# 1 Virtual Link Control (VLC) Overview and Architecture

2 **Editorial Note:** This is clause 4

1 **2 VLC sublayer**

6 **Figure 2-1—VLC sublayer functional block diagram**

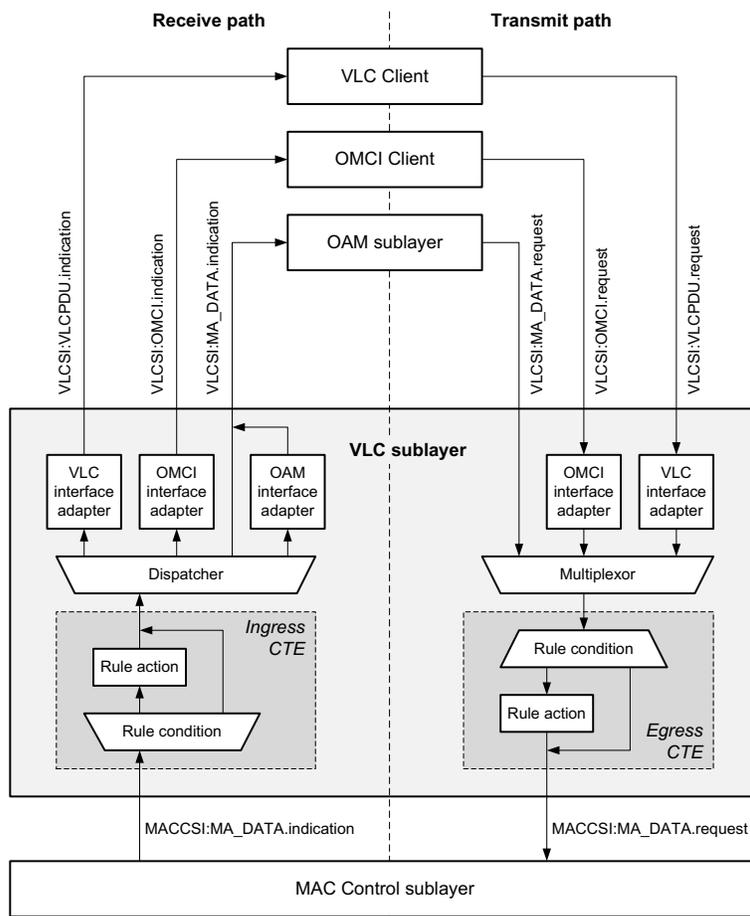
3 [The VLC Sublayer is where xPDU-to-VLCPDU and VLCPDU-to-xPDU conversions take place. The](#)  
4 [internal functional structure of the VLC Sublayer is shown in Figure 6-1.](#)

Moved (insertion) [1]

Moved up [1]:  
Figure 6-1—VLC sublayer functional block diagram

Deleted: Figure 6-1

7 [The VLC sublayer includes a set of interface adapters and the Classification and Translation Engine \(CTE\).](#)  
8 [Together these functional blocks convert xPDUs into VLCPDUs and vice versa. The CTE behavior is](#)  
9 [governed by a set of rules that are either statically configured or dynamically provisioned by the NMS \(see](#)  
10 [2.1\).](#)
